GOVERNMENT OF TELANGANA  
FOREST DEPARTMENT

Rc.No.135/2018/D1/M2,dt.29/12/2022

Sub: TS - Forest Department - Forest (C) Act, 1980 - Diversion of 2.121 Ha. of  
- Forest land for formation of approach road for construction of HLB across  
Manjeera River from Dharmareddy to Muddapur (Via) Venkampally Road PR  
Road in Kamareddy District in favour of Executive Engineer, R&B Division,  
Kamareddy - EDS raised by IRO, Hyderabad - Report submitted - Reg.

Sub: Diversion of 2.121 Ha of Forest land for formation approach road construction of HLB across Manjeera River from Dharmareddy to Muddapur via Venkampally road PR road in Kamareddy district in favour of Executive Engineer (R&B) Division Kamareddy –EDS raised by IRO Hyderabad- submission of reply- reg.

Encl.: Maps-(2 sets)

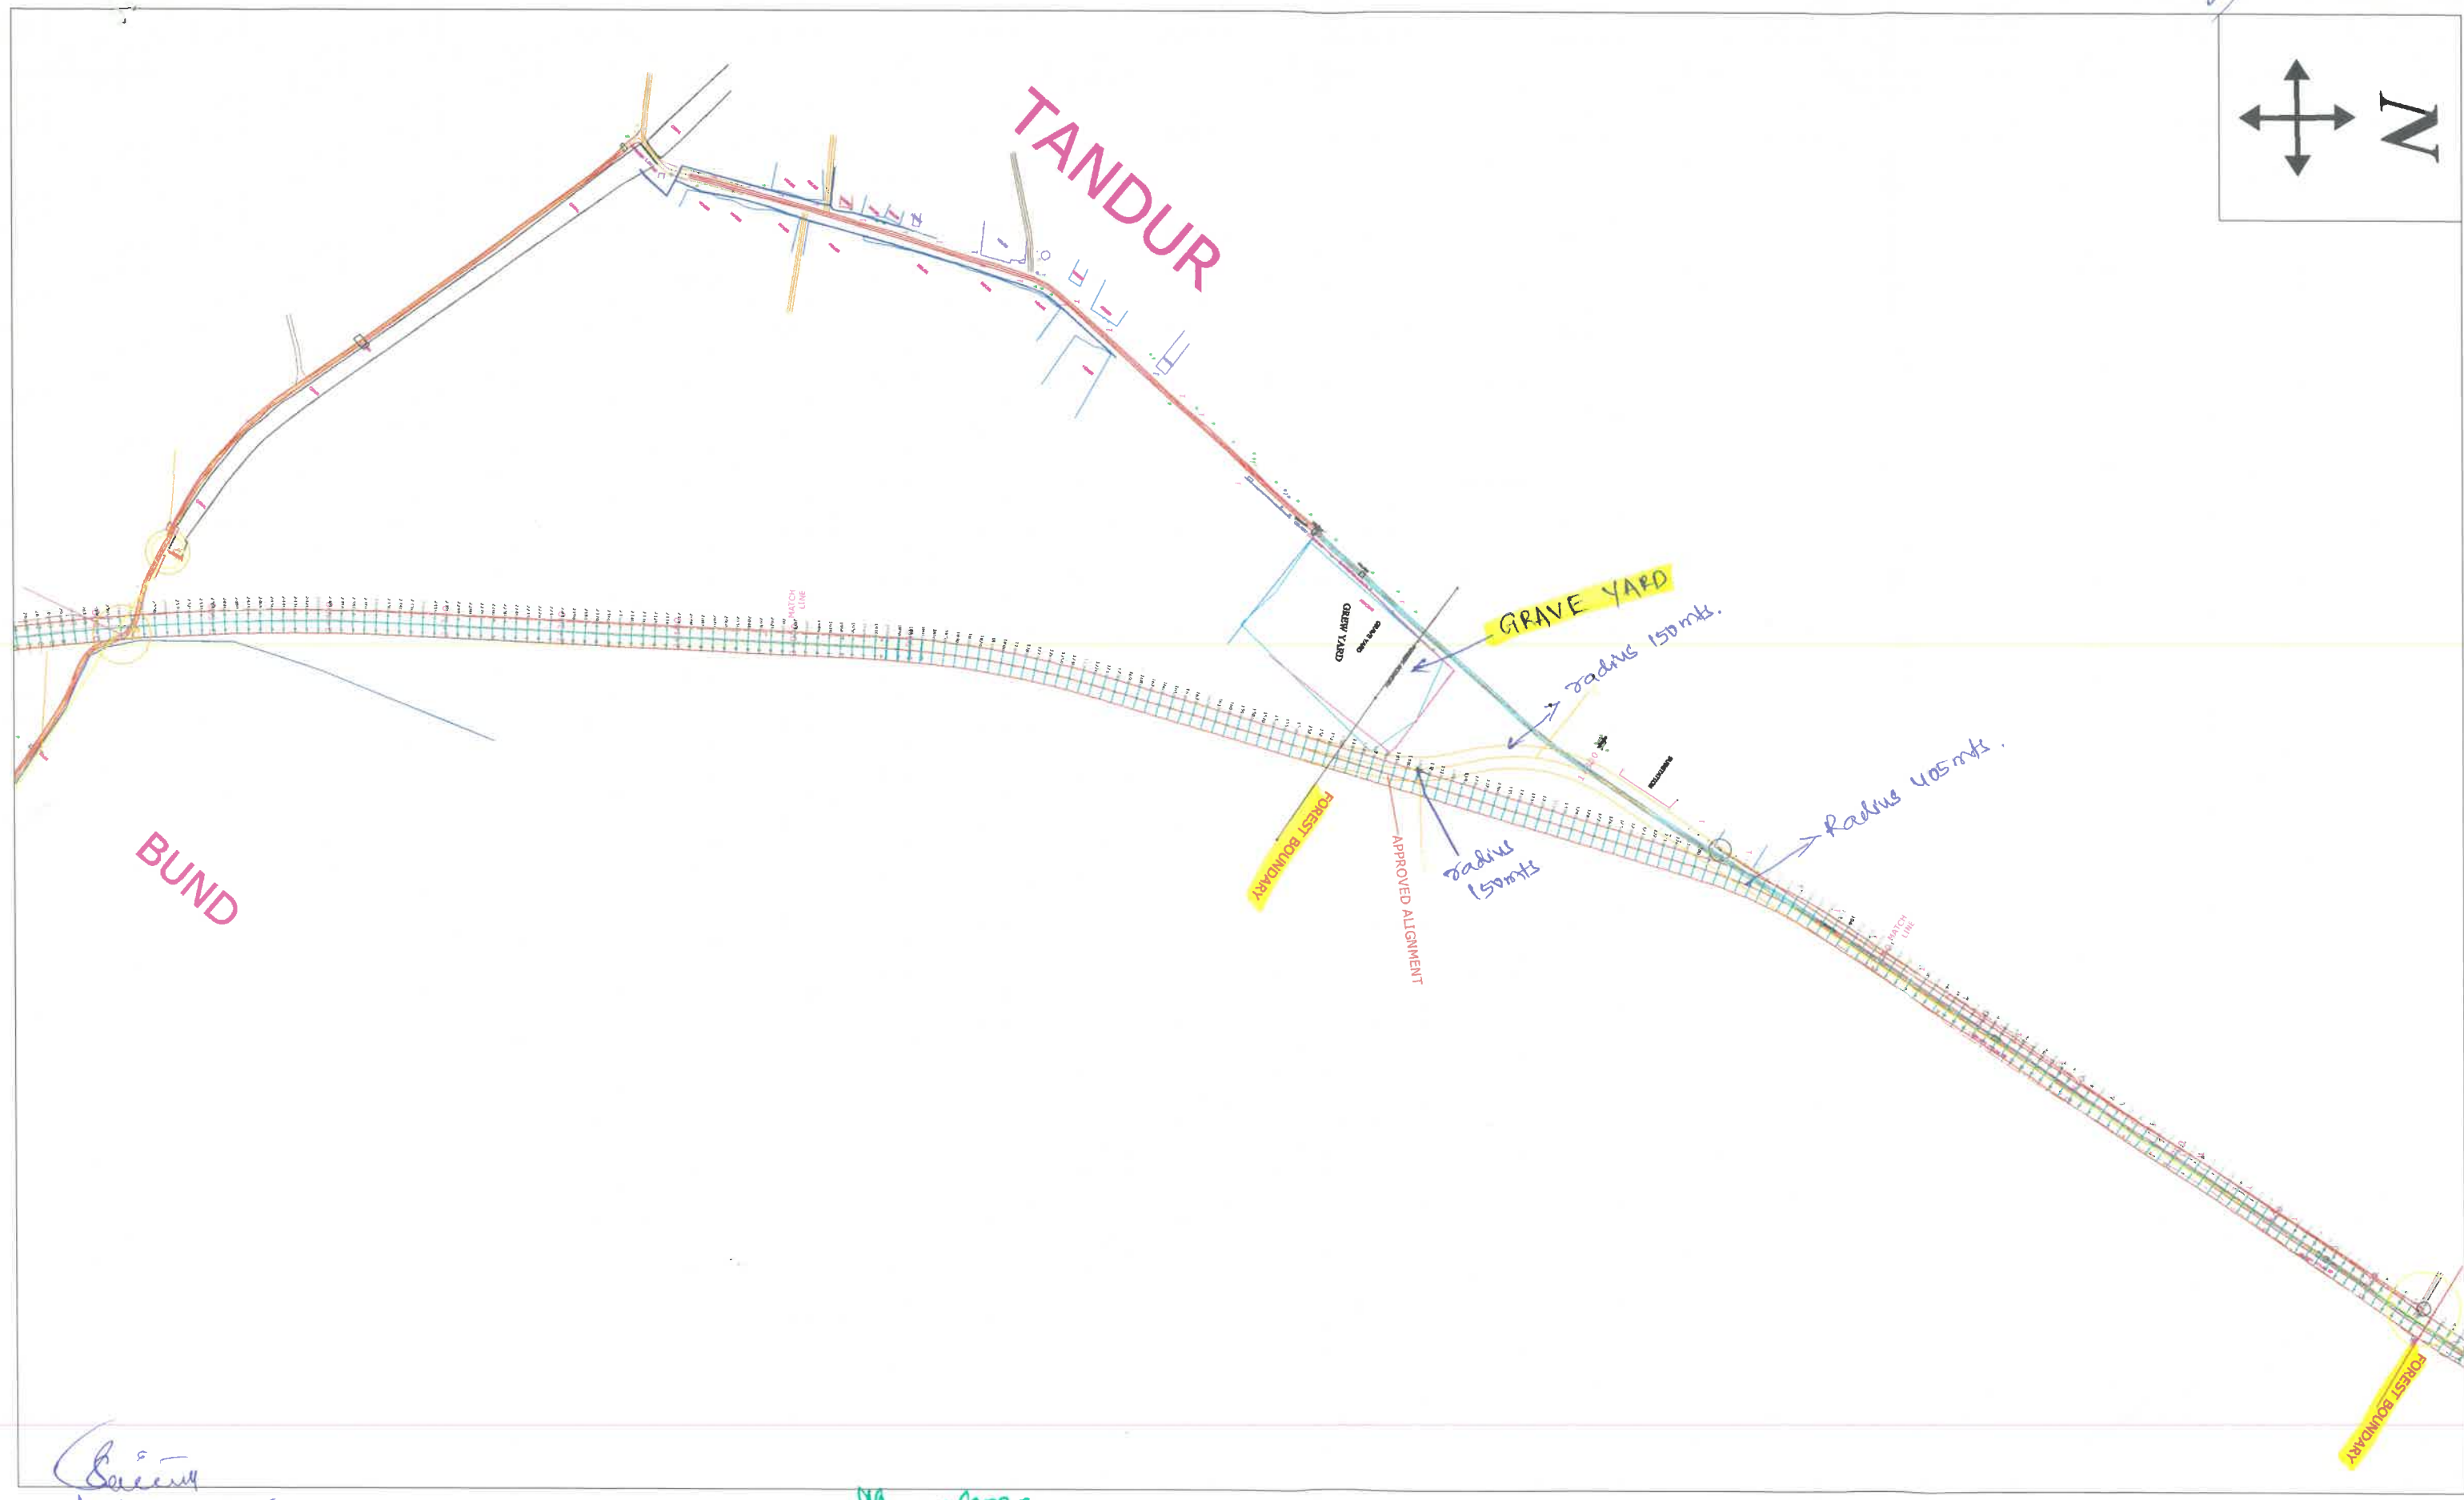
Adverting to the reference cited, wherein the IRO MoEF & CC, GOI,

Hyderabad has directed to realign the road along the boundary of the forest land.

Accordingly resurvey was conducted and it is found that the realignment is not possible due to following reasons.

- i) Presence of grave yard and in continuation houses of Tandoor village.
- ii) This road connects two National highways i.e. Hyderabad-Medak-Bodhan road (NH.765D) and Sanagareddy-Nanded-Akola road (NH161). Hence, the minimum radius desired is 400meters in accordance Indian road congress code IRC SP 84-2014.
- iii) If we try to use existing road to the extent possible, we have to introduce curves which are less than 400m radius. By introducing the S curve the road is prone to accidents.

Hence , it is not possible to realign the road. However the proposed alignment was proposed duly using the maximum extent of the existing road on the forest land (i.e.from km.0/450 to 1/100) and deviating from the existing road with radius 405m and just abutting the grave yard.

In view of the above, I request the Dist. Forest Officer, Kamareddy kindly consider alignment already proposed and obtain the Stage-1 approval "Diversion of 2.121 Ha of Forest land for formation approach road construction of HLB across Manjeera River from Dharmareddy to Muddapur via Venkampally road PR road in Kamareddy district."
